Project Name:	Park Manor Senior Public School – Phase 2	Date Issued:	February 25, 2022
Quasar Project #:	ED-20-301		
Client Tender #:	7266-RW-22		
Addendum #:	E-1		
Revision #:	0

Park Manor Public
 School - Phase 2
 Renovations

ELECTRICAL LEGEND & SHEET
 LIST

1 PARTIAL SITE PLAN - ELECTRICAL
 SCALE: 1:500

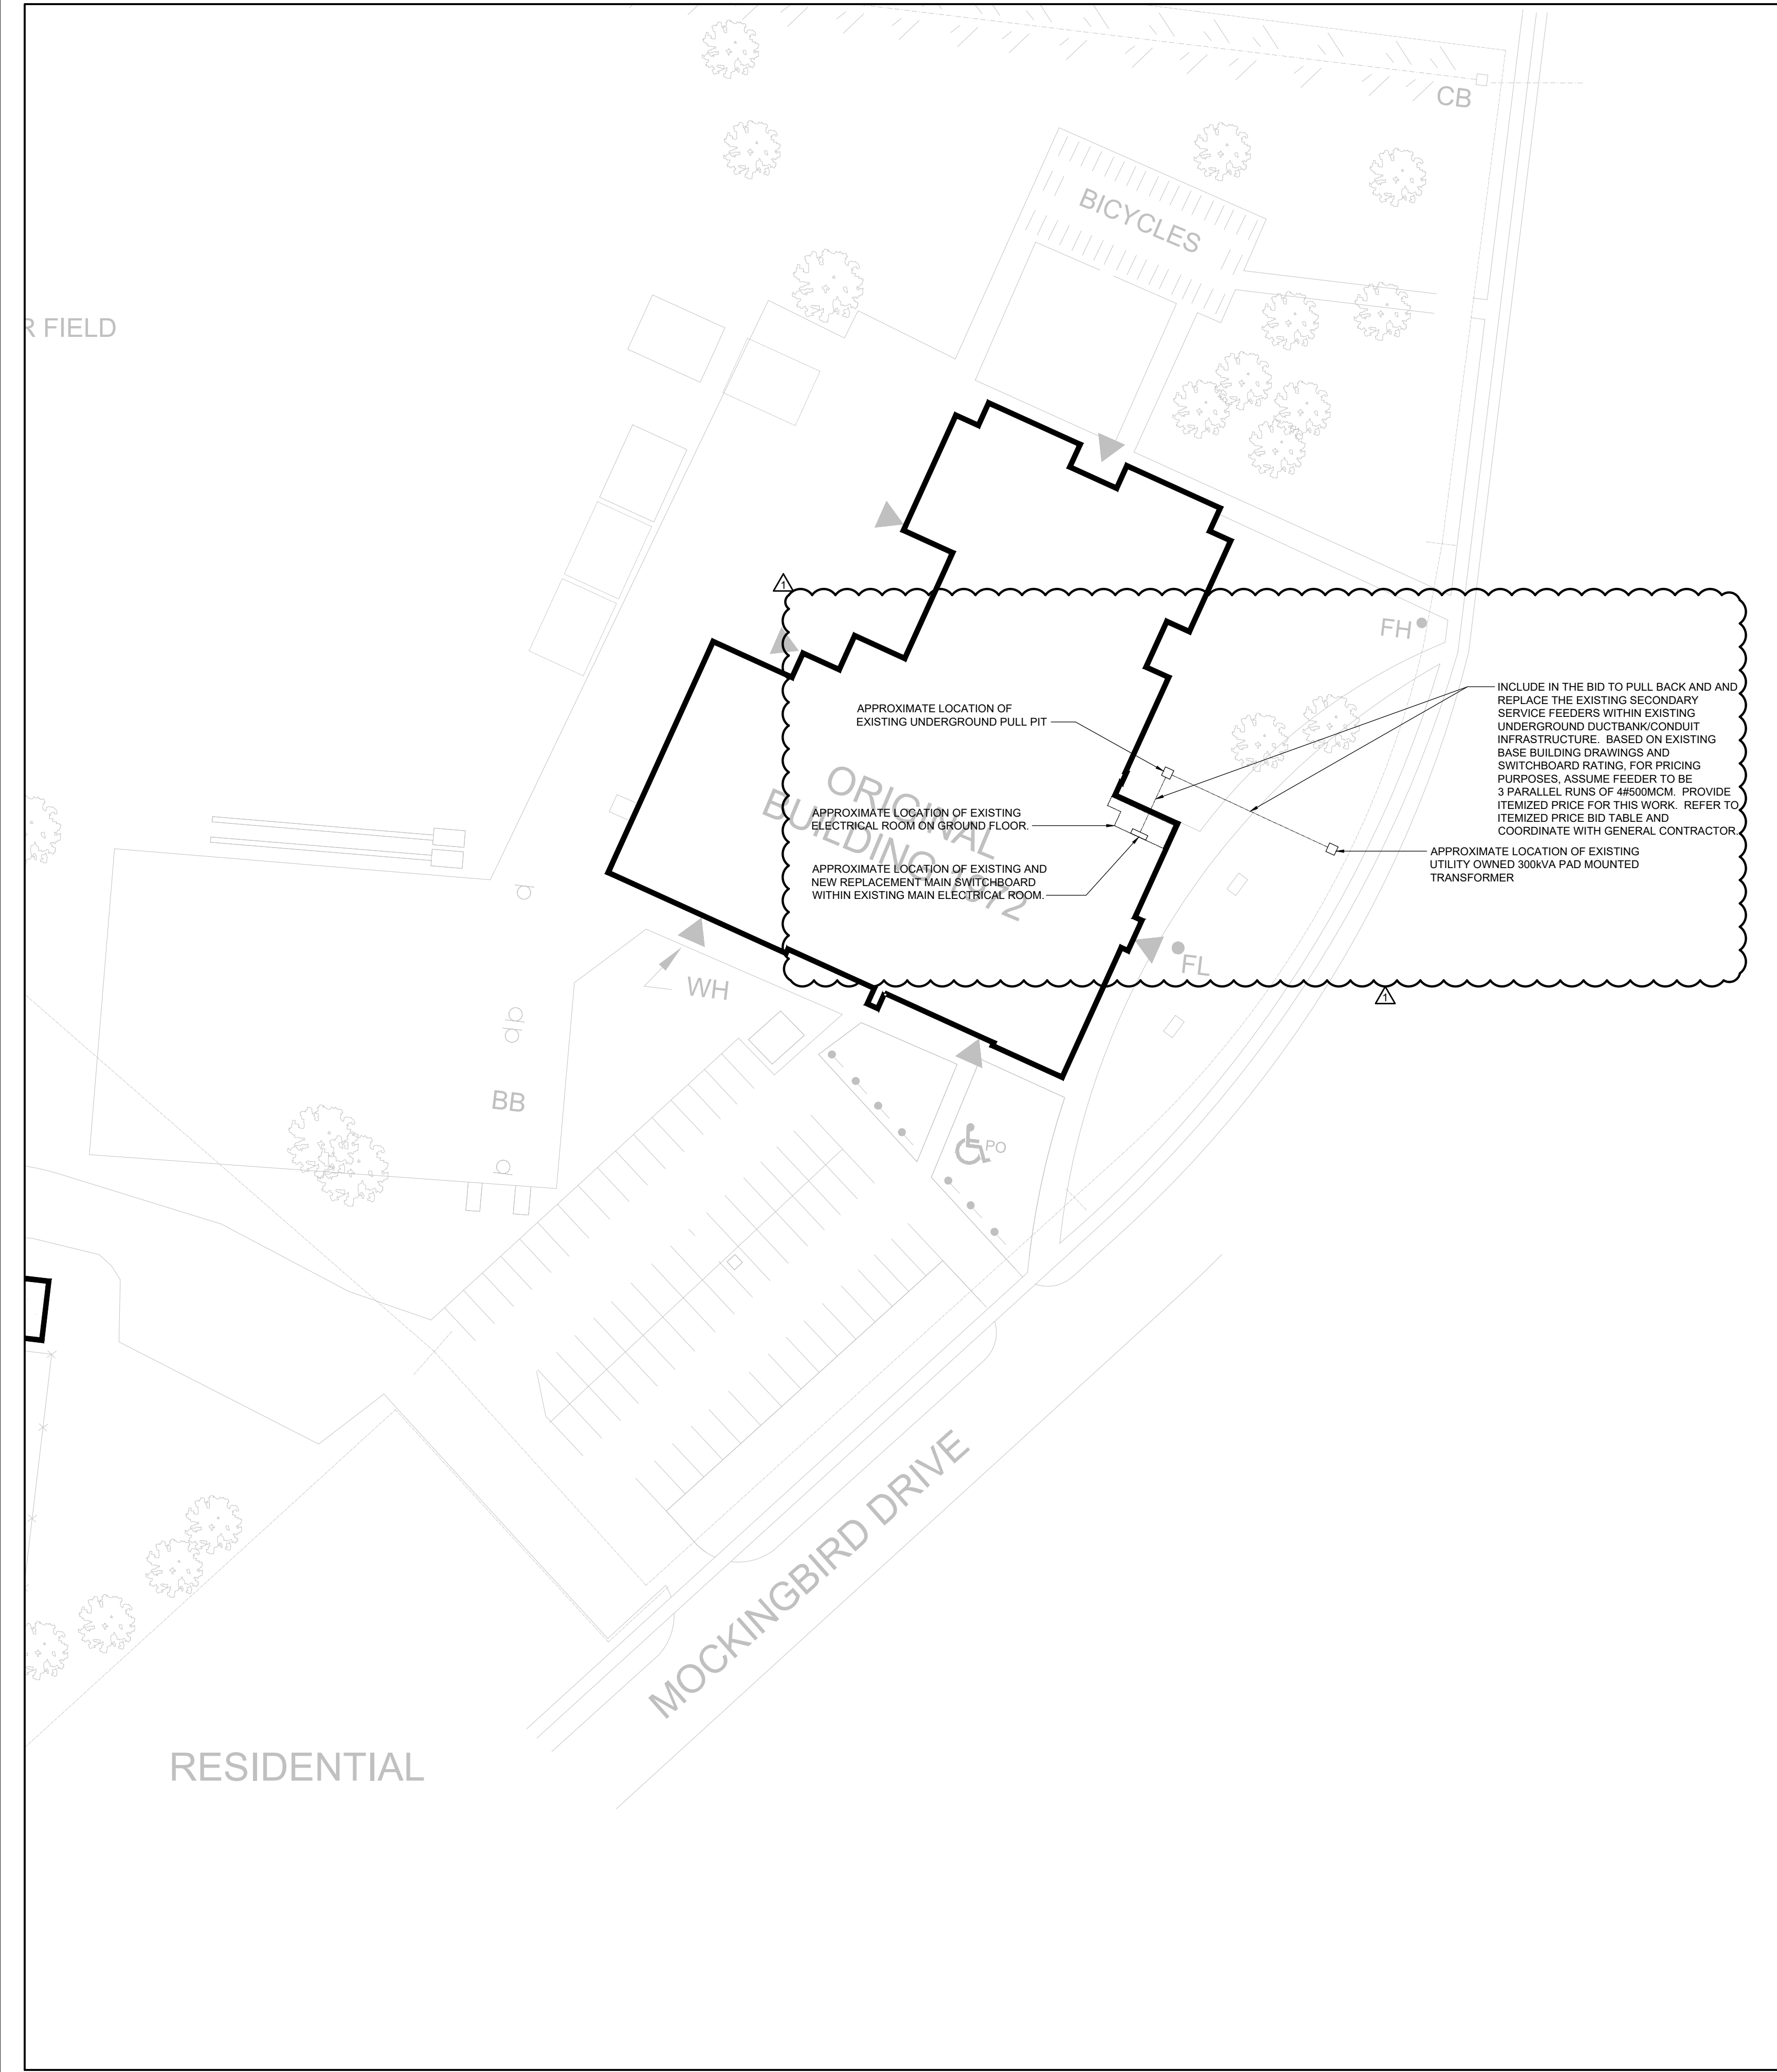
1. DRAWING E001 – ELECTRICAL LEGEND AND SHEET LIST (ISSUED HEREWITH)

- a. Refer to attached, revised drawing E001 and note addition of a site plan to this drawing. Contractor shall include for pulling back of existing underground secondary service cabling and replace with new feeder. Size of existing and new feeder is noted on the drawings. Include itemized price in the bid form for this work. Refer to Architectural Addendum 01 for the Itemized Price bid table. If existing cables are found to be in good condition and of sufficient length to accommodate the replacement of the existing switchboard, a credit shall be provided for this work. Contractor to verify on site prior to commencement of any replacement and arrange power shut-down with Owner and Hydro Utility (Waterloo-North Hydro) for investigation purposes.

- a. Contractor to include for pulling back and replacement of existing underground secondary service cables between existing pad mounted transformer near the street and new main switchboard. Size of existing feeders is noted on re-issued drawing E001. Include itemized price in the bid form for this work. If existing cables are found to be in good condition and of sufficient length to accommodate the replacement of the existing switchboard, a credit shall be provided for this work.
